Service Bulletin

Bulletin No. 2008-08
OEM No. 2008-07

Official Recall Notification U.S. Federal Boat Safety Act - Shift Link 2.5 Liter

37631

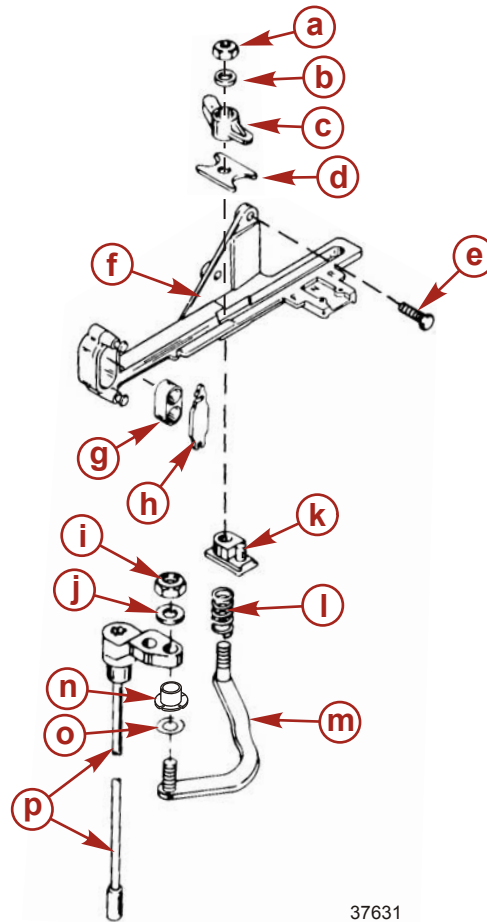
Some shift links may have insufficient weld penetration between the link and shift cable and upper shift shaft attaching studs. This could result in possible stud breakage and loss of shift control.

- a** - Shift latch nut - tighten until one thread on shift link stud is exposed above nut
- b** - Shift latch washer
- c** - Shift latch
- d** - Wear plate
- e** - Anchor bracket screw (3)
- f** - Anchor bracket
- g** - Shift and throttle cable barrel cup
- h** - Barrel latch
- i** - Shift link nut to upper shift shaft – tighten and back off 1/4 turn
- j** - Shift link washer to upper shift shaft
- k** - Guide block
- l** - Guide block spring
- m** - Shift link
- n** - Shift link bushing to upper shift shaft
- o** - Wave washer
- p** - Upper shift shaft

37914

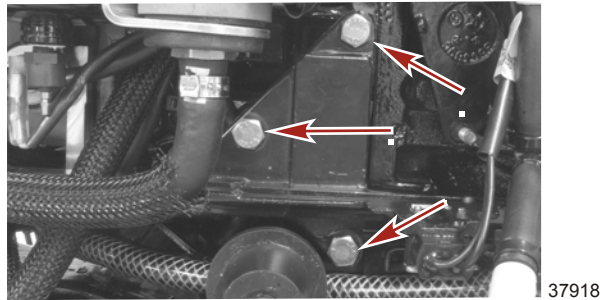
1. Remove the top cowl.
2. Locate the shift cable latch on the anchor bracket on the port side of the engine.
3. Check for a paint mark on the shift latch. If a paint mark is present, the engine has already been reworked and no further action is required.
4. If no paint mark is present on the shift latch, shift the engine into reverse while rotating the propeller shaft. Shifting into reverse will make it easier for inspection and/or removal of the shift link.
5. Using a mirror and flashlight and/or feeling with your fingers, determine if the weld on the shift link directly below the stud is good or bad. See instructions with photo below.
6. If a good weld is found, no further action is required.

a - A good weld will appear, or feel, as a raised bump directly below the stud on the bottom side of the shift link

b - A bad weld will appear, or feel, indented directly below the stud on the bottom side of the shift link

If a bad weld is found, replace the shift link using the following steps:

37921

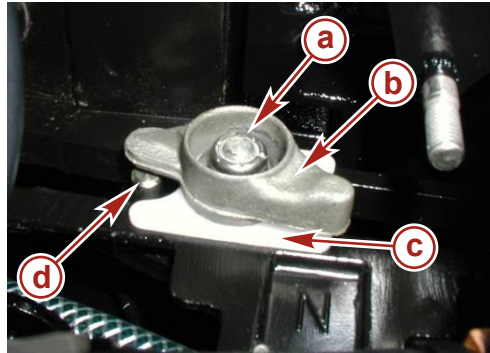
- a** - Shift latch nut - one thread exposed
- b** - Shift latch

- c** - Wear plate
- d** - Guide block pin

- Install the wear plate and shift latch.
- Tighten the shift latch nut until one thread on the shift link stud is exposed above the nut.
- Mark the shift latch with a green or white paint dot to show that it has been reworked.
